Renzo L. White  
75 Brigham Hill Lane  
Essex, Vermont

Re: DRIVEWAY DESIGN - 75 Brigham Hill Lane, Renzo White  
Date: July 5, 2016  
To: Town of Essex Planning & Zoning – Sharon Kelley  
From: Trafton Crandall P.E.

To: Sharon Kelley, Town Zoning Administrator  
Greg Duggan, Town Planner  
From: Dennis E. Lutz, P.E., Public Works Director  
Aaron K. Martin, P.E., Utilities Director / Town Engineer  
Date: July 21, 2016  
Subject: 75 Brigham Hill Lane  
Simple Parcel Subdivision

RURAL DRIVEWAY

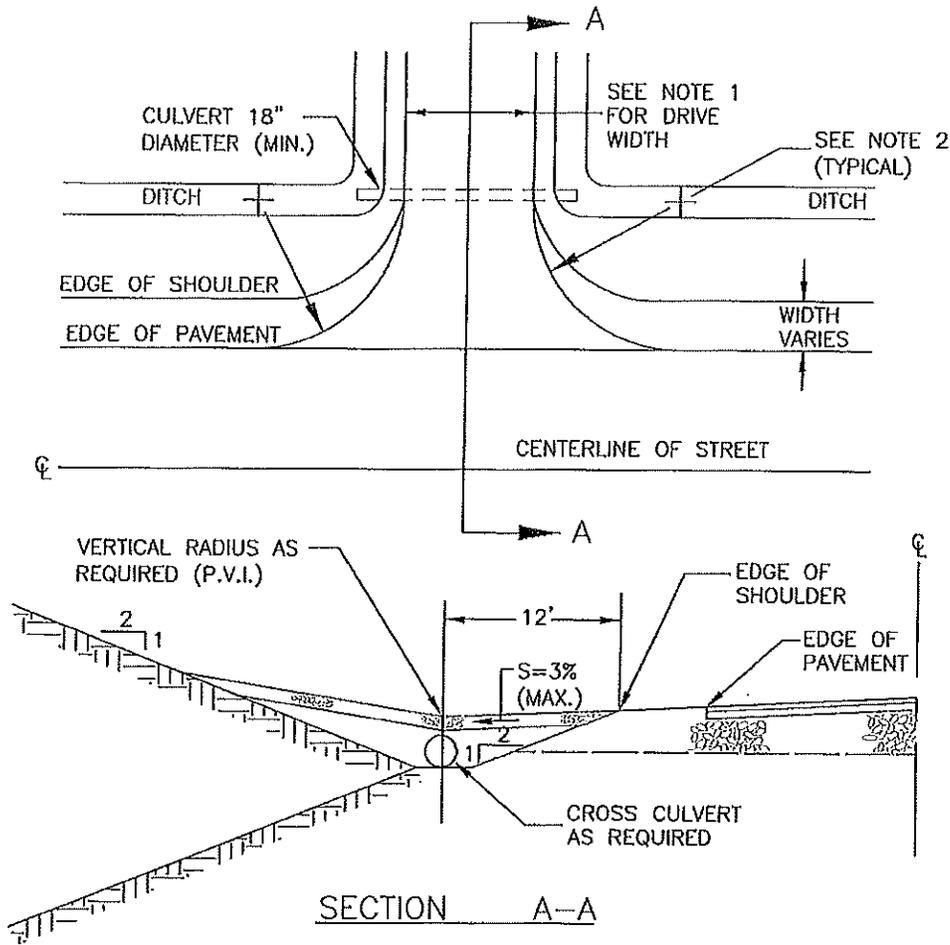
2. It appears the applicant will be constructing a new curb cut for proposed Lot #2 and utilizing the existing curb cut for Lot #1. The drive location for Lot #2 will require the following upgrades.
  - a. The applicant must apply for, and receive approval from the Public Works office for the new curb cut to Lot #2. (Application Attached)
  - b. The applicant shall construct the new drive as directed in the attached detail.
  - c. All vegetation, 50-feet either side of the centerline of the proposed drive to Lot #2 within the Town R.O.W., shall be cleared.

1. All storm water impacts caused by the increase in proposed impervious area must be mitigated onsite and not allowed to impact surrounding properties or the Town R.O.W. No Exceptions.
2. The applicant will be required to install a drive culvert for the proposed drive to Lot #2. The minimum pipe diameter shall be 18-Inches. Refer to the attached curb cut detail for further direction.
